# Release A CDR RID Report

**Date Last Modified** 10/13/95  
**Originator** Gary Veum, Hal Folts **Phone No** 301-286-1073  
**Organization** V0 networks, ESDIS  
**E Mail Address** gary.veum@gsfc.nasa.gov  
**Document** Overview of Release A SDPS and CSMS System Design  
Specification for the ECS Project.

<b>RID ID</b>	CDR 87
<b>Review</b>	SDPS/CSMS
<b>Originator Ref</b>	DSNO 2
<b>Priority</b>	2

**Category Name** ISS Design **Actionee** ECS  
**Sub Category**  
**Subject** Single switch-router architecture

Response to CDR RID 87: Possible R-B Network Topology Separating Processing and User Flows

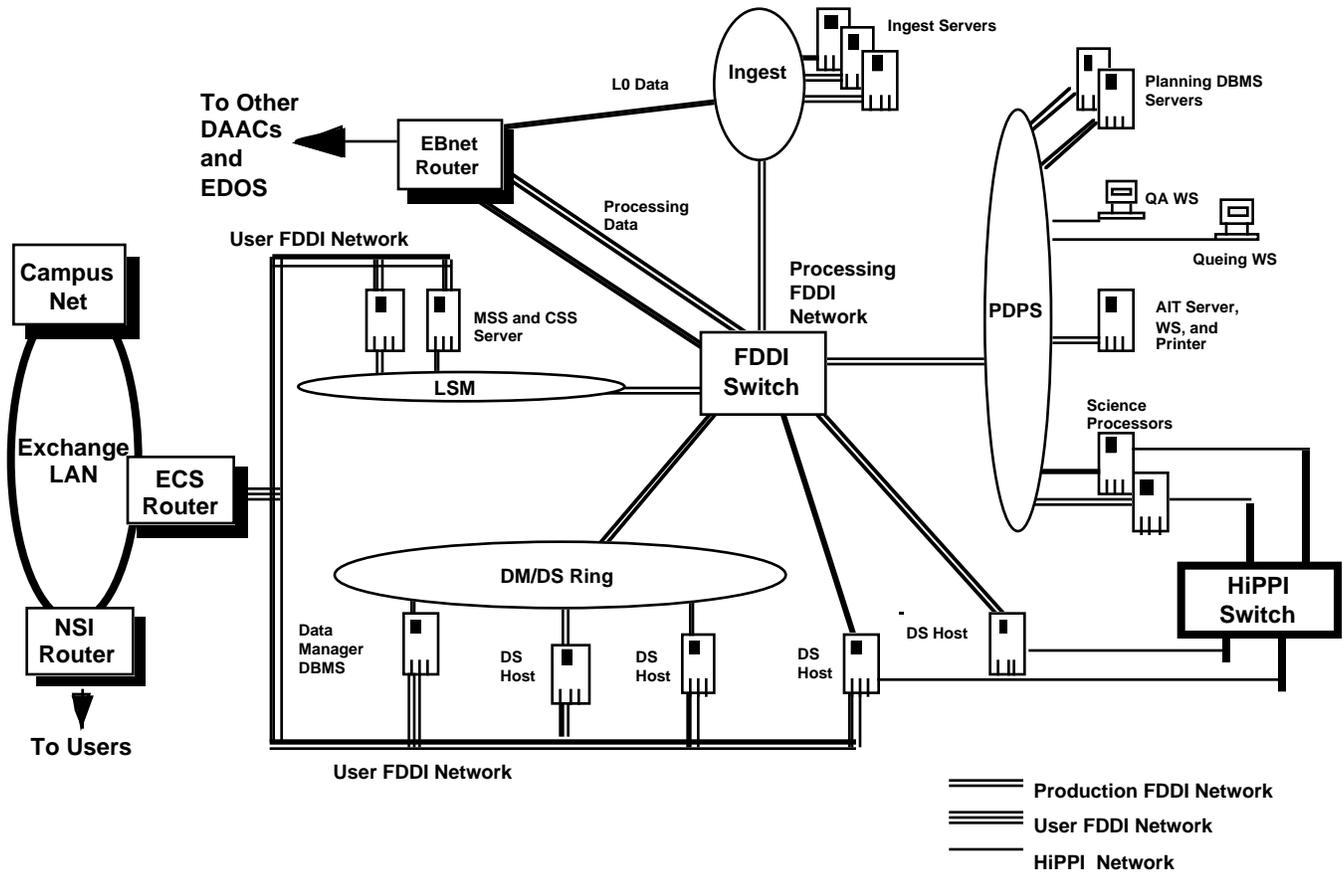
The design architecture of having production and Internet traffic come through the same switch and EBnet router may not be robust enough or scalable for future needs in Release B and beyond.

ECS should show that the proposed architecture can clearly handle the Release A loads, including all down time, scheduled and unscheduled, and including all peak loads for Release B. Since the design must scale to Release B, ECS should explain the evolution path to more robust and scalable design architectures, specifically, the capability necessary to separate the ingest flows, the inter-DAAC flows, and the outflows to the Internet and QA SCFs, in an evolutionary way as needed in the future.

2) Because the network loads in R-A are small, the R-A topology is adequate to handle all flows (both user and processing) on the same architecture. In R-B, this will not be the case at some DAACs (such as LaRC and GSFC), due to the large increase in data flows.

In the larger R-B facilities, the user and processing flows will be separated so that each flow uses different network resources. This may be accomplished by installing a second FDDI network to handle only user flows (which would connect only to those machines interacting directly with the users) and keeping the R-A FDDI network for all the processing flows (such as for L0 ingest and for receipt of DAAC-DAAC flows). Also, given the high processor requirements, HAIS is considering connecting the Science Processors and Data Server machines via a high-speed technology such as HiPPI. This would allow the very large data transfers required for staging and destaging data to be handle by a totally separate network. (This network would not be IP-based and would be transparent to the users and other DAACs.)

HAIS is continually evaluating topologies to handle the increased loads in R-B and beyond, and is involved in several prototyping efforts to meet these loads. A possible topology reflecting the above discussion is shown in the attached diagram. A more detailed (but still preliminary) design for migration to R-B will be presented at the R-B IDR in October/November 1995. The final design for migration to Release B will be presented in the R-B CDR currently scheduled for March/April 1995.
